Approved Section 4.55 (.....2.....) Modification Application

Project
BARANGAROO STAGE 1B
PUBLIC DOMAIN
Modification S4.55

Drawing Title
**HICKSON PARK WEST ENTRY
DETAIL PLAN - NO TREES**
Drawn
SS

Sheet No24..... of55.....

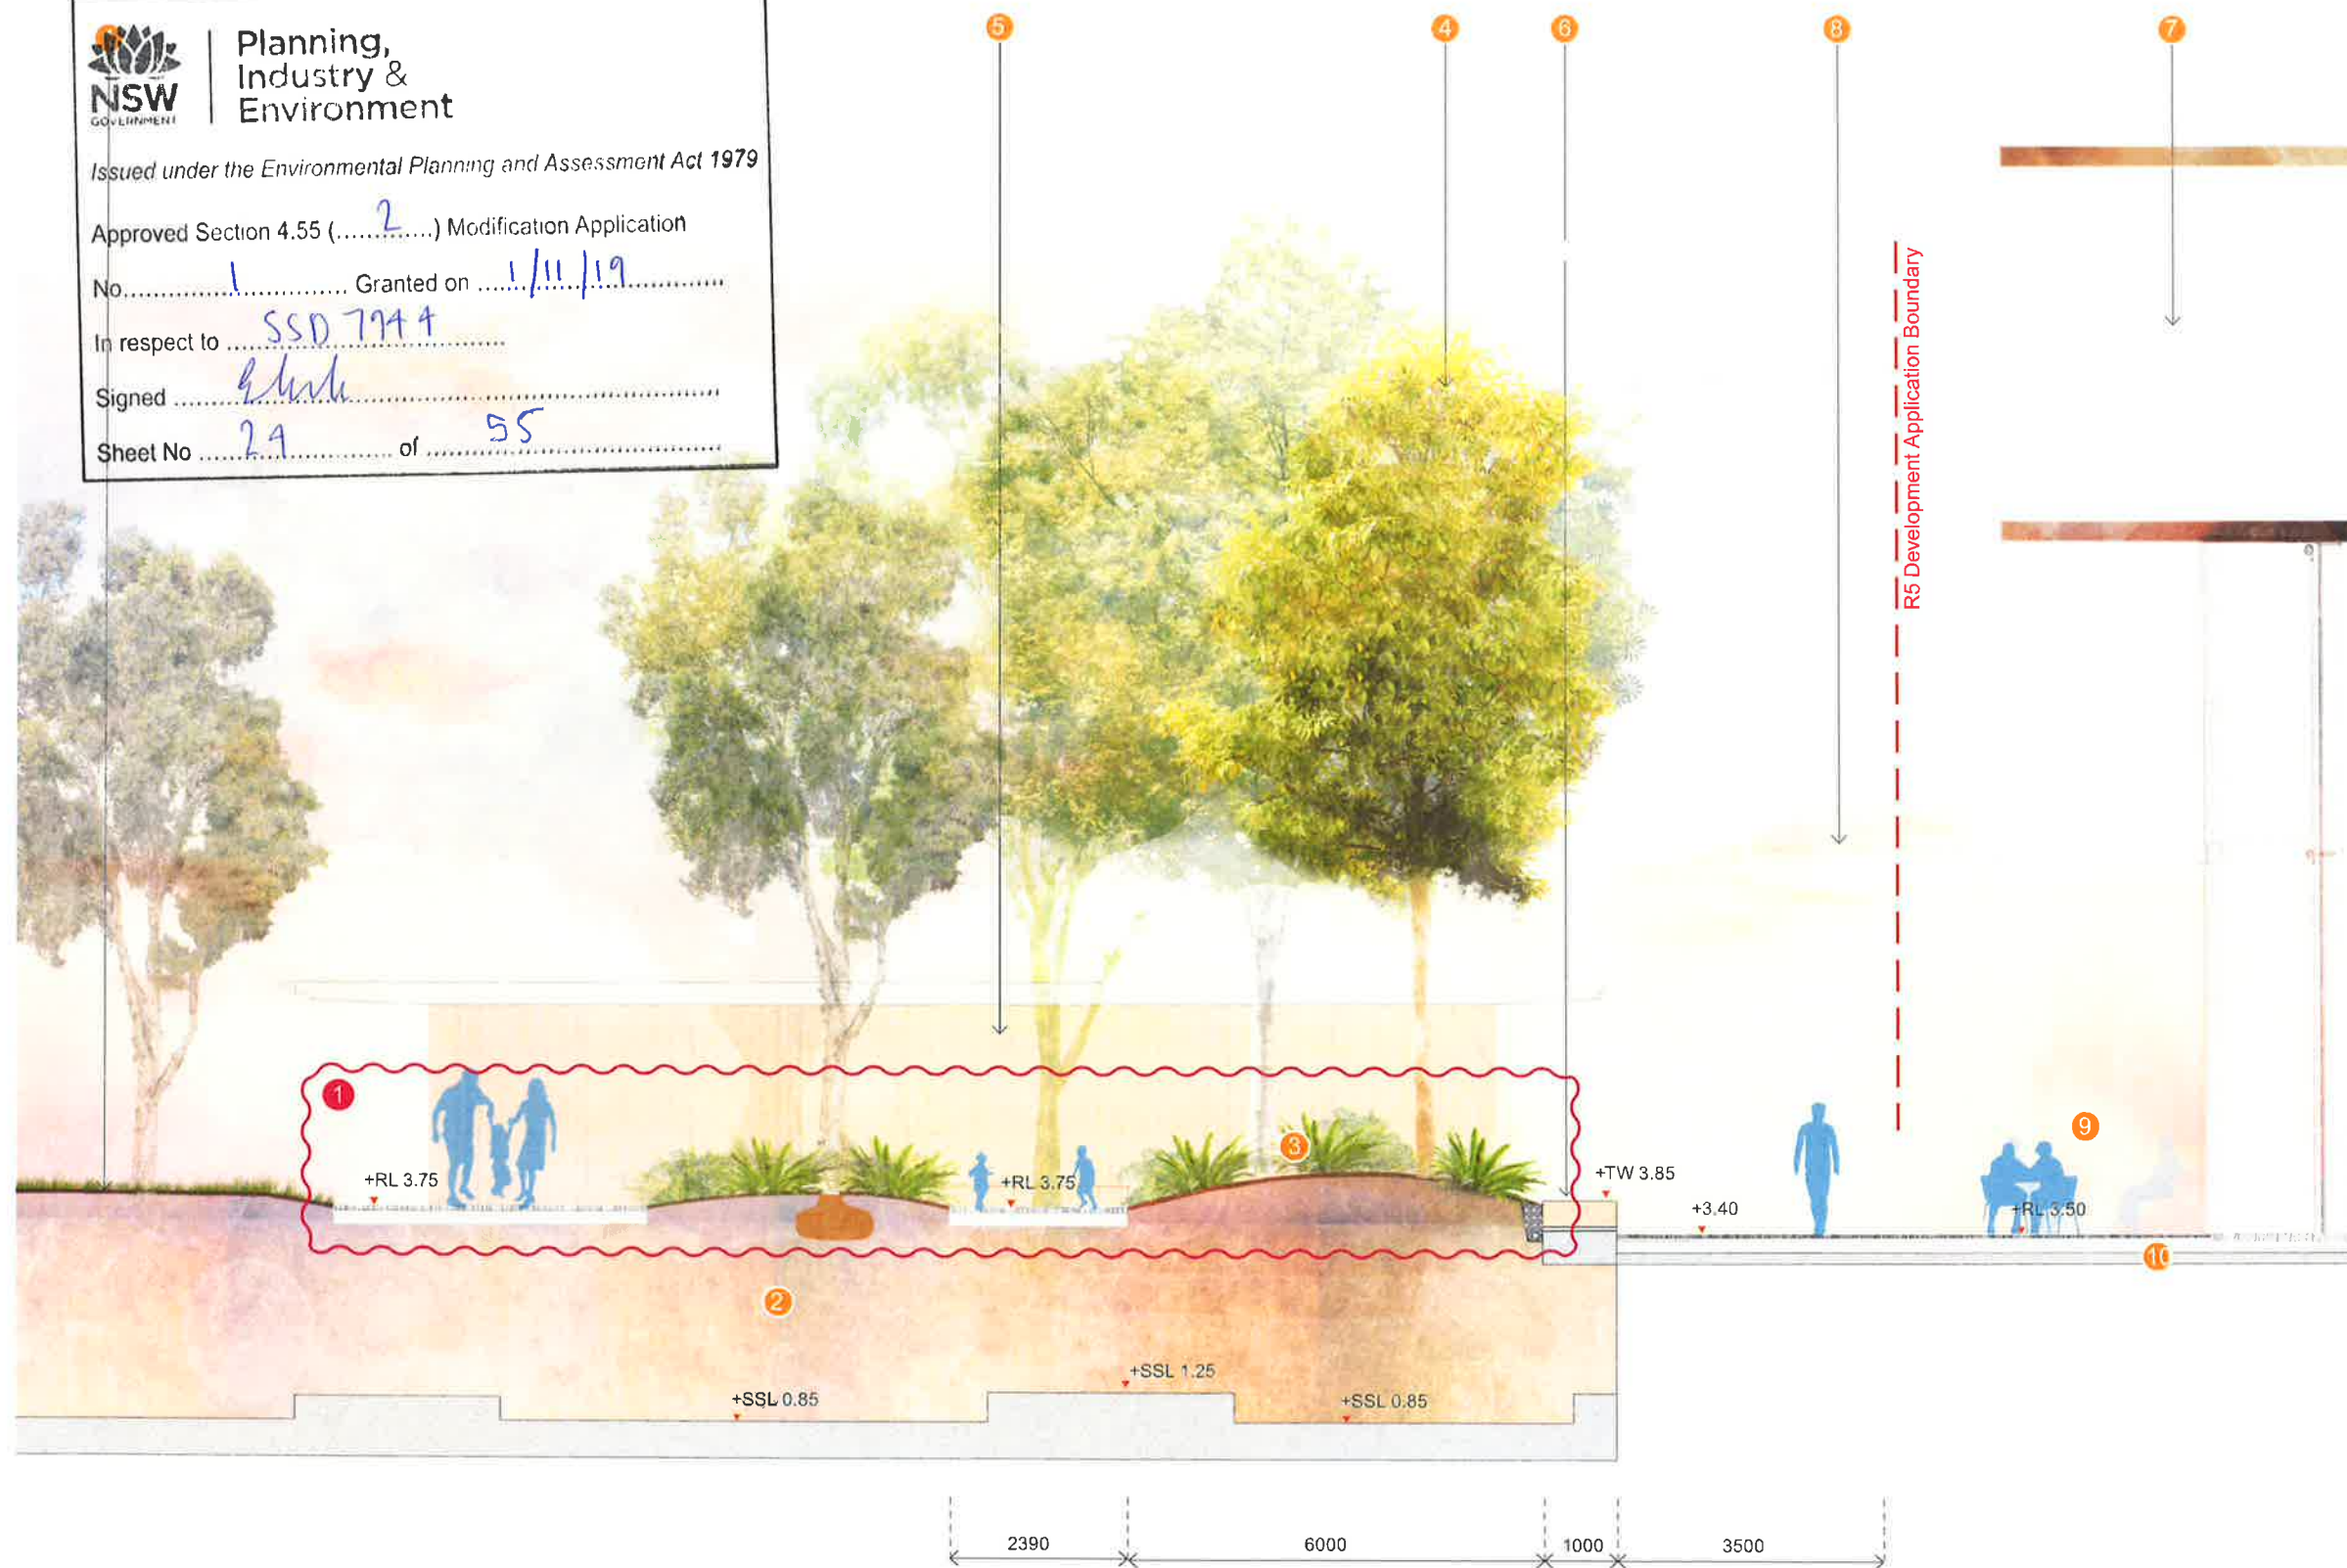
- Proposed Modifications**
- 1 Increase planting area within the park and change of geometry.

Sheet No 25 of 55

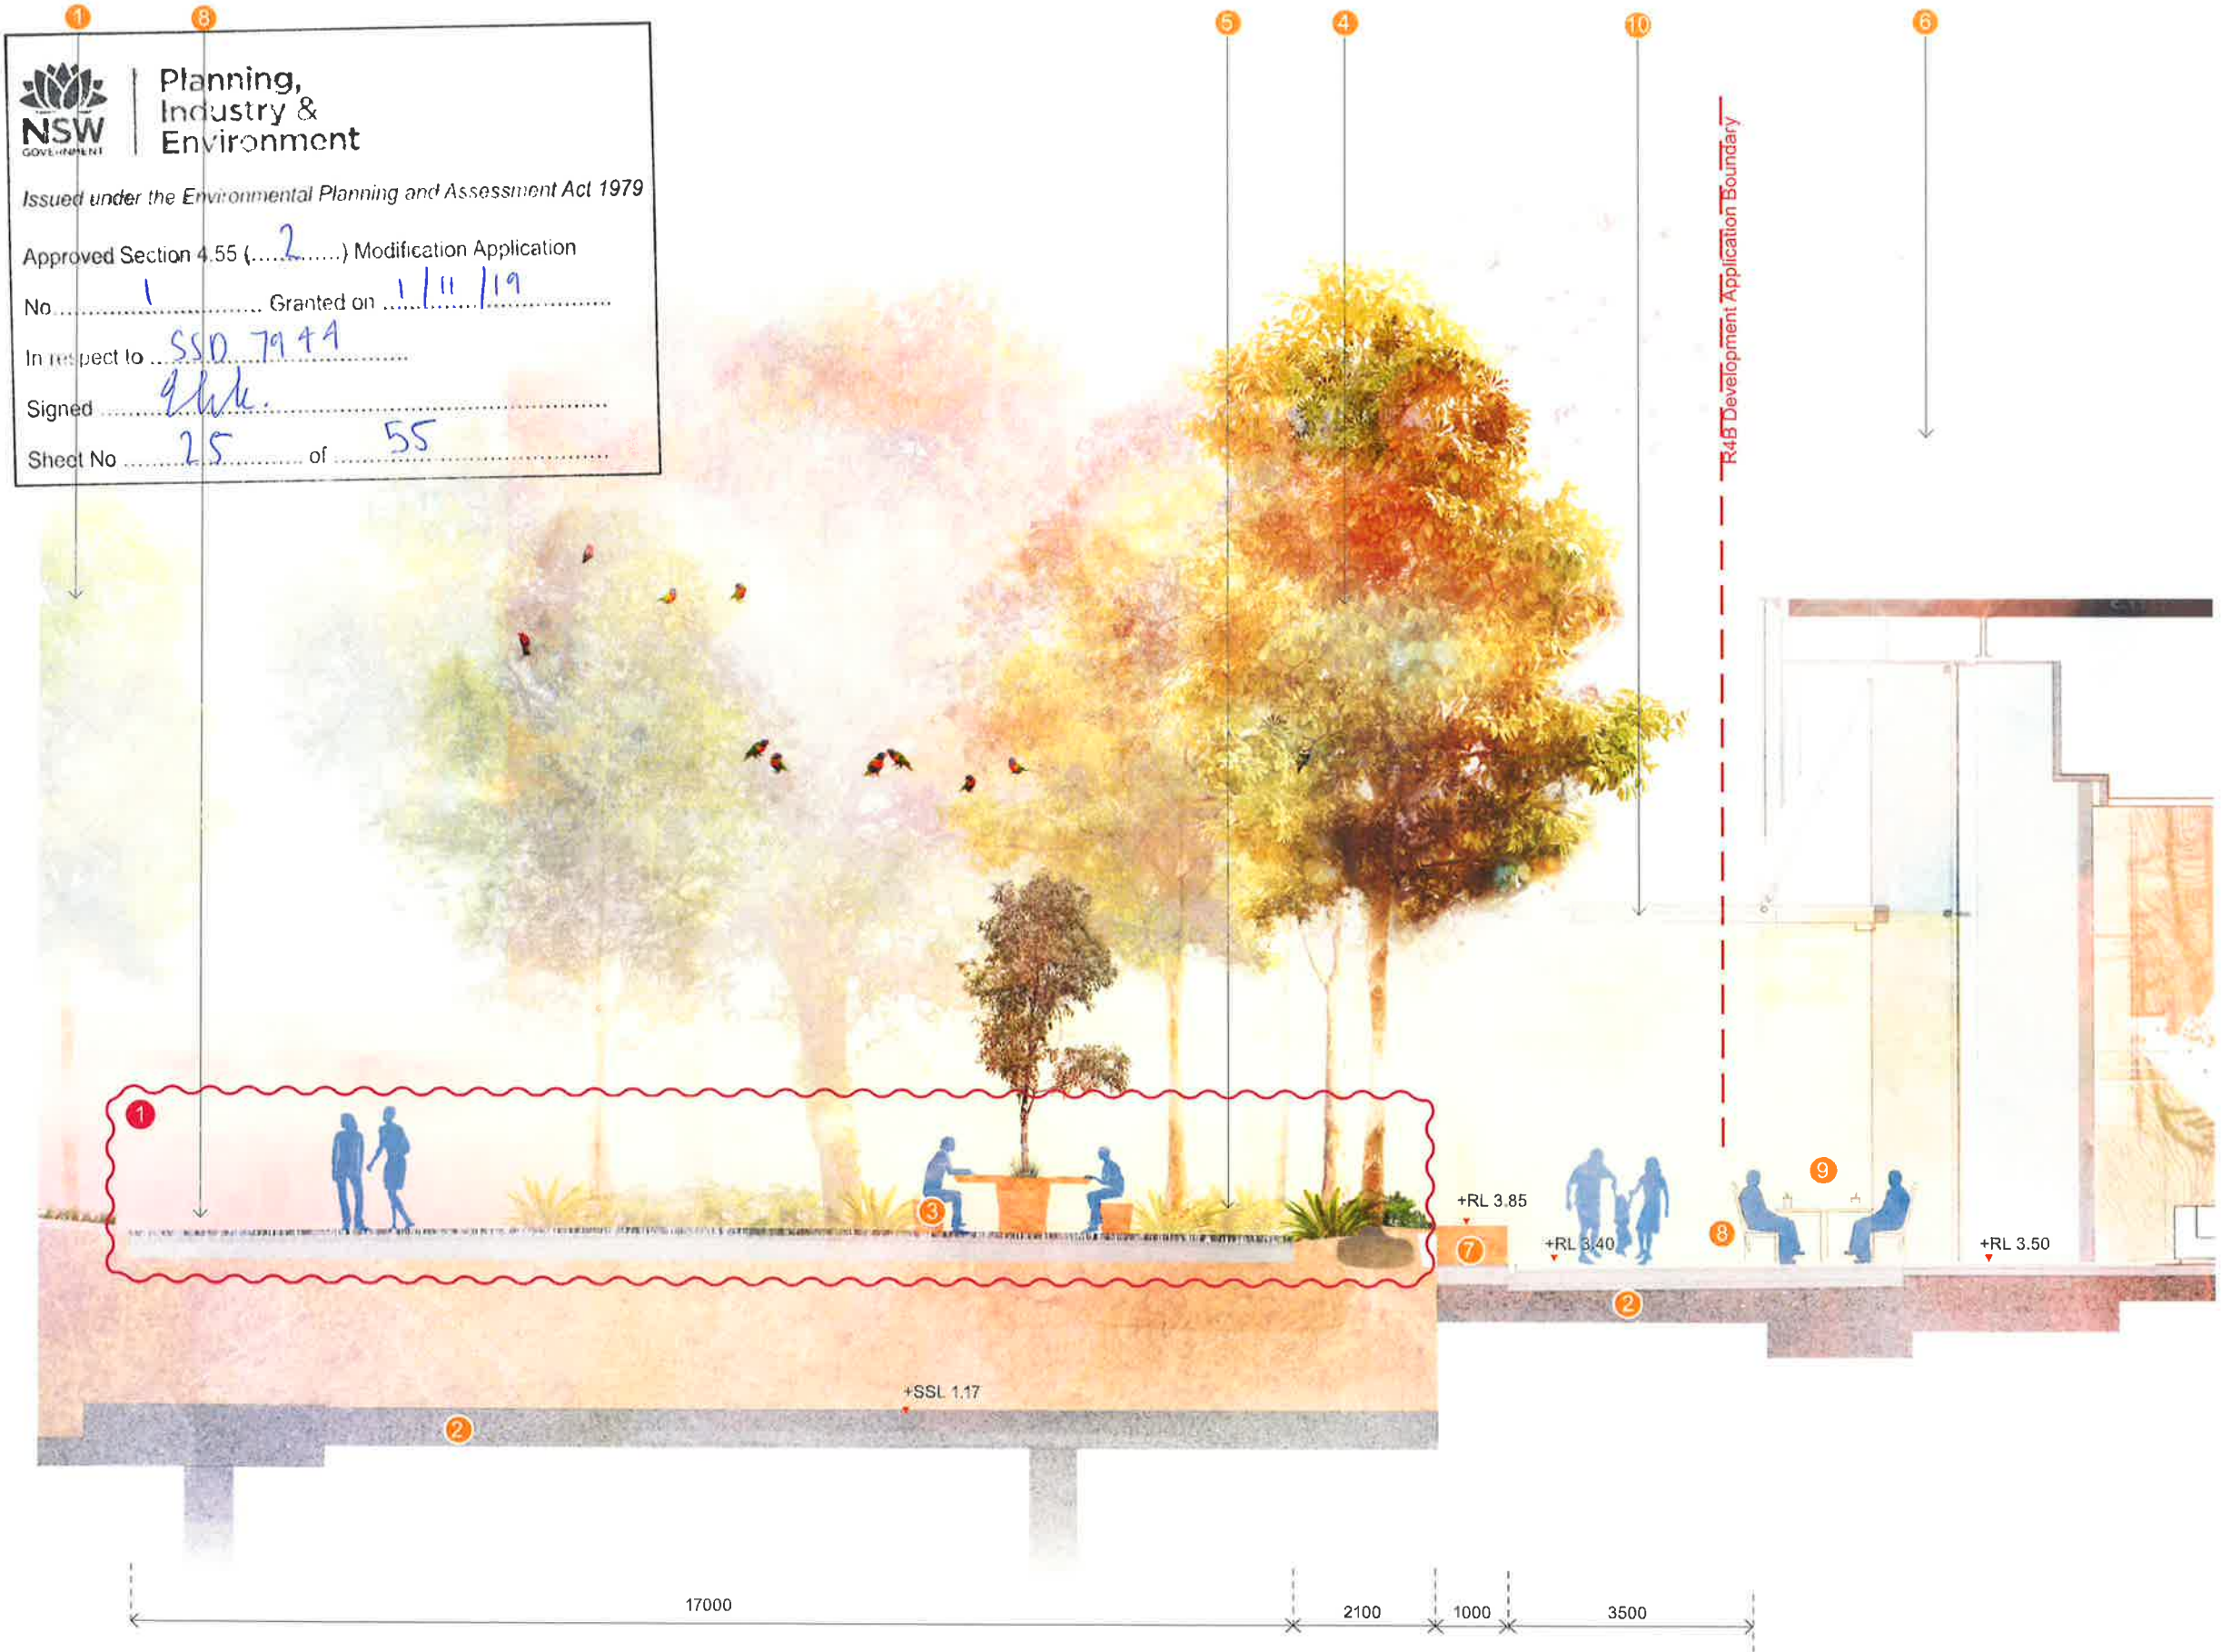
- Proposed Modifications
- Amendment cloud
 - 1 Increase planting area within the park and change of geometry.

Sheet No 26 of 55

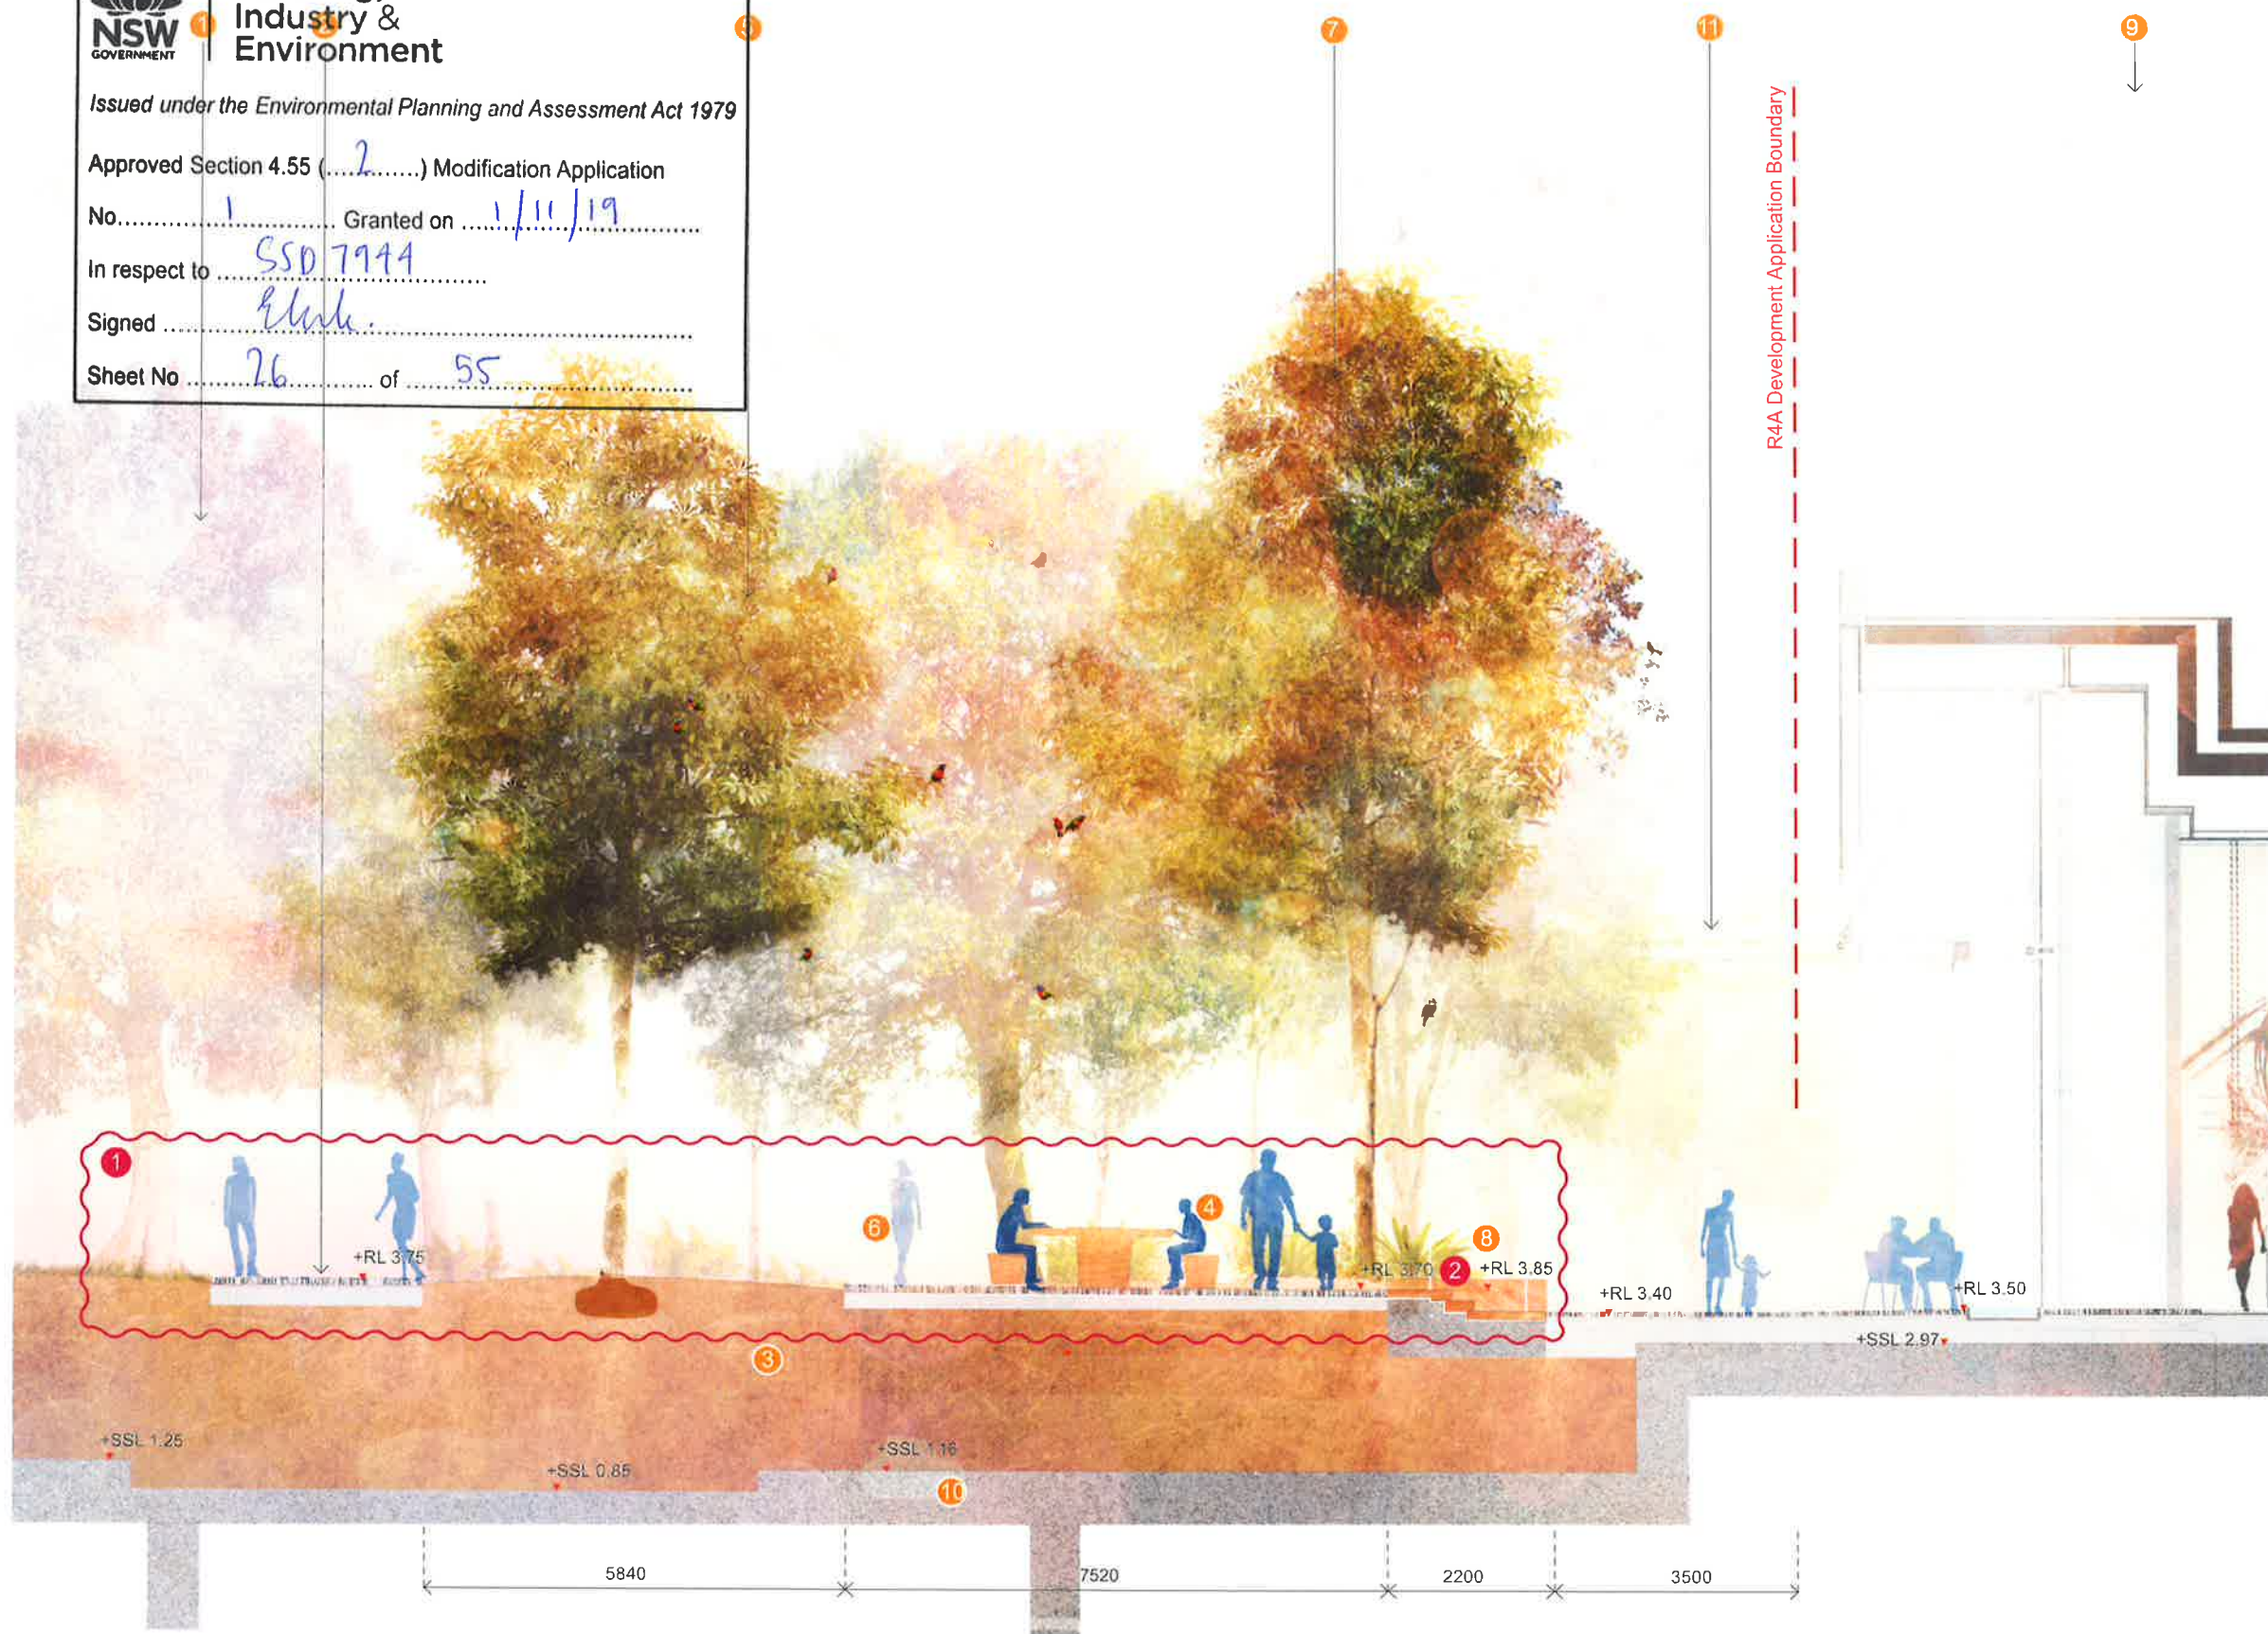
-  Amendment cloud
- 1 Increase planting area within the park and change of geometry.
- 2 Stone stairs changed to concrete
